# Service Technical Information

MODEL NO.	CDC-X146M/X1460M/X176M/X1560/X1760M/X1765M R136/R146M/R176M
SUBJECT	Malfunction of CD player

REF.No. :G - 99 - 052 - E1

DATE :08. DEC. 1999

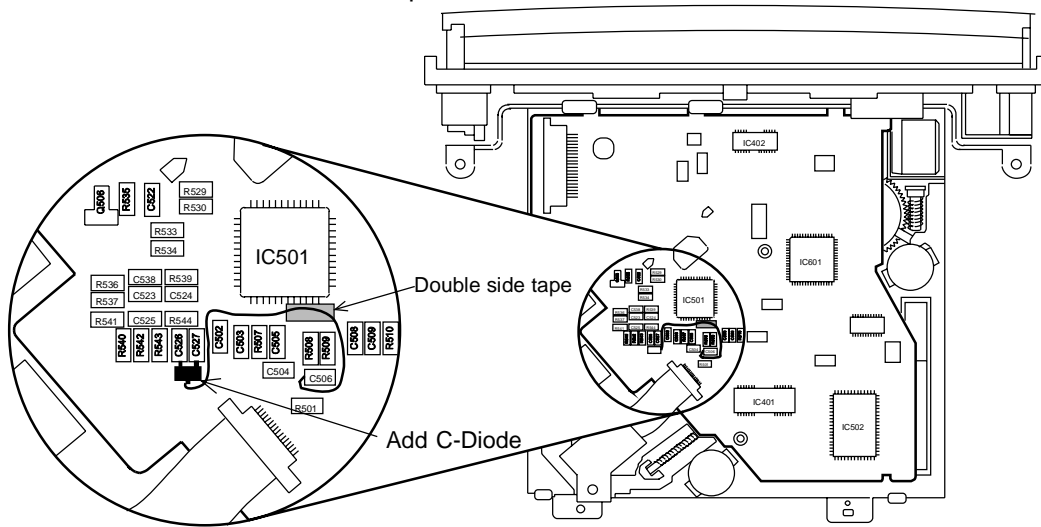
Revision issue of wiring correction as follows

Add chip diodes to the CD P.W.B with the following procedures:

- 1) Add a chip diode (DAN217) to the CD P.W.B located at the bottom of CD mechanism Assy.
  - Solder Pin1 and Pin2 of the chip diode onto chip capacitors C526 and C527.
  - Solder a wire onto the Pin3 of the chip diode.
- 2) Solder the other end of the wire onto chip capacitor C506.
- 3) Fix the wire with double-sided tape.

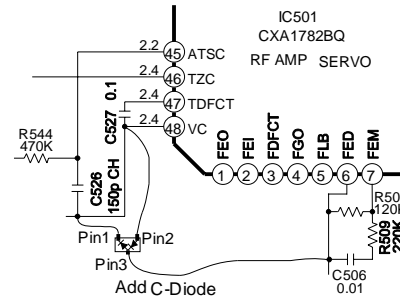
- A pickup may have been damaged. Check a pickup upon repair work.
- Pay attention to conductor traces under a diode. Affix a sheet under a diode for insulation.
